6 July 2009

Mass Transit Railway (MTR) Western Island Line (WIL)
Grave Impact on The Belcher's
Our Meeting, 4:30-6:15PM, 30 June 2009 and your letters of 3rd and 17th June 2009

Exhibit B – Suggested location for delivery duct

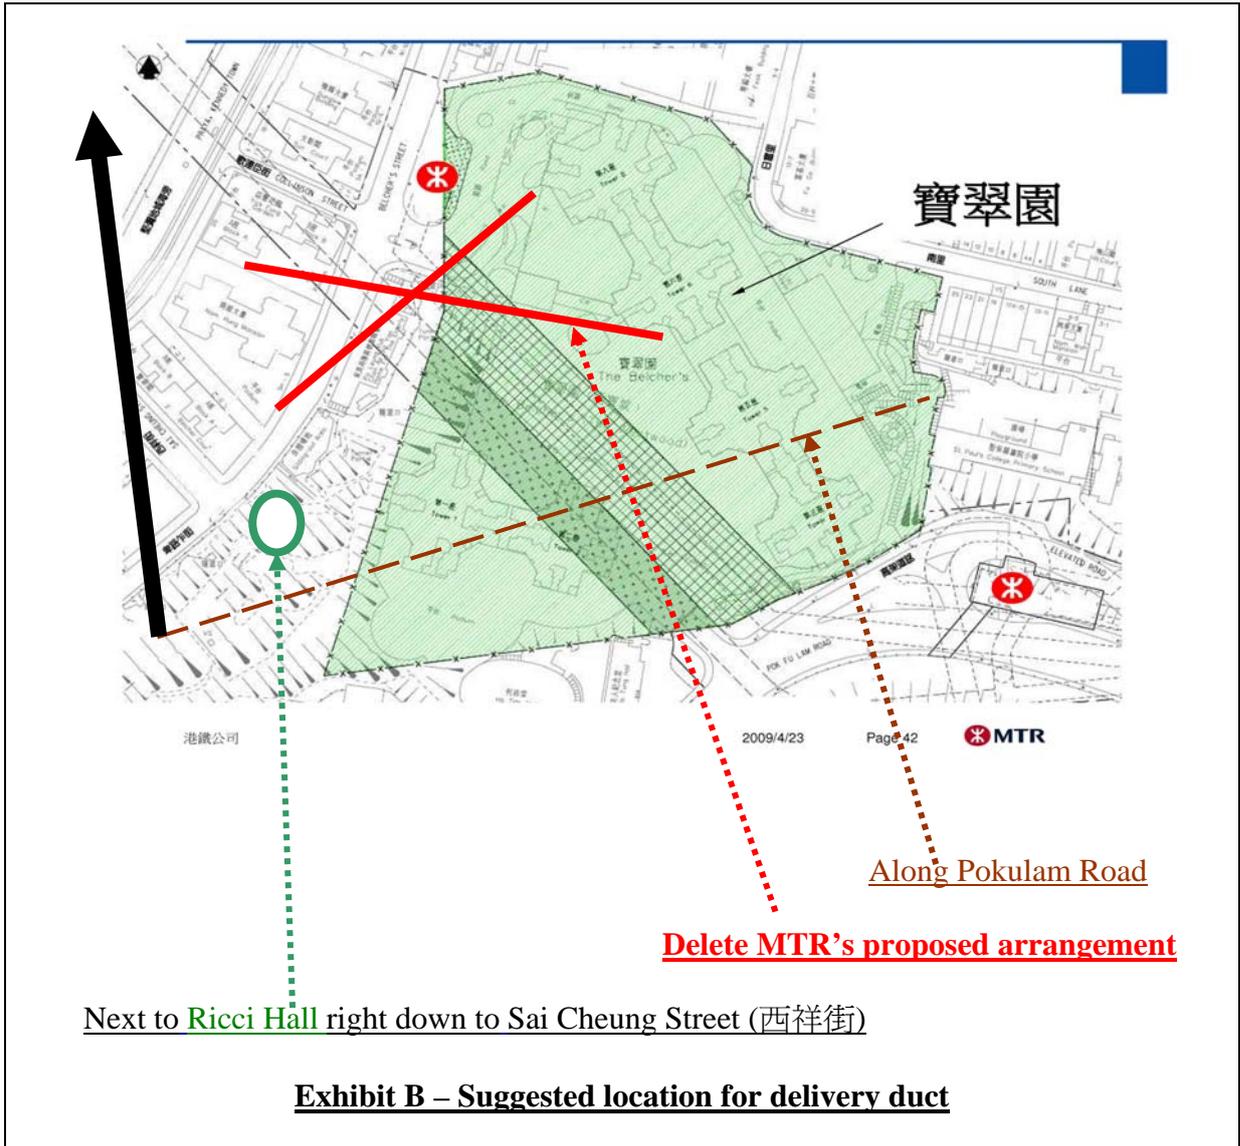
Next to Ricci Hall right down to Sai Cheung Street (西祥街)

Delete MTR's proposed arrangement

Along Pokulam Road

- 6.1 **Provide evidence of the alternatives that you claimed to have considered and the reasons for their rejection.**
- 6.2 **Examine our proposed alternative site, and give us your reason to reject it if that's the case.**
- 6.3 **Show us that The Belcher's is in fact included in the list of risk factors in your risk analysis if you still claim that you have done one.**

Diagram A

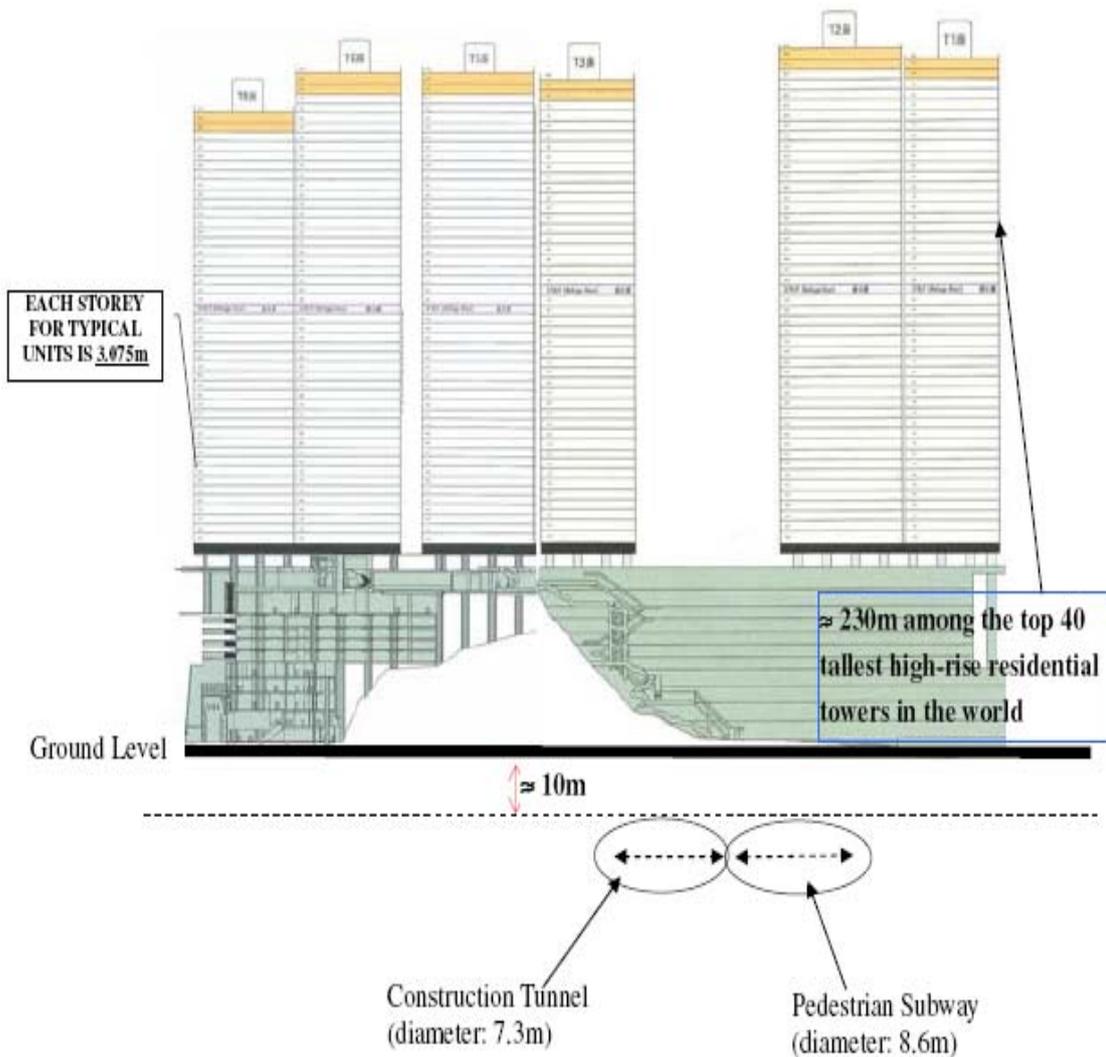
4.3.1 If performing an EIA means that you have met government regulations for safety, then it is an abysmal mistake. By your own admittance, the parameters include only risk factors related to transport, storage and use of explosives, not anything related to potential threats to the structure and foundation of the buildings directly above the sites of blast. We are sitting over two huge holes (see Diagram A). How can we feel safe? How you claim we are safe?

- 5.2 However, after having heard my explanation, you replied that you used the formula only during planning, and would not use it afterwards. My explanation goes as follows: in mathematical language, when taking limit of both sides and an equation as a selected variable becomes so small, it is expressed by the phrase "approaching zero; the actual value for that variable is in fact zero or small in relative terms with respect to some factors in the environment. In this case, the distance is 10m (your data), and the Belcher's building above is 230m. We are talking about a scale of

23:1. (See Diagram A which is reiterated here for your convenience.) As can be seen in the following computation:

$$\lim_{D \rightarrow 0} \{PPV\} = \lim_{D \rightarrow 0} \{644 (D/\sqrt{W})^{-1.22}\} \rightarrow \infty$$

- 5.3 The enormity is demonstrated by the enormous vibration produced by the blast when the distance of interest is relative small, whatever the amount of explosive used. The interpretation of this result tells us that if anything that is theoretically unviable, then how can we expect practical viability?
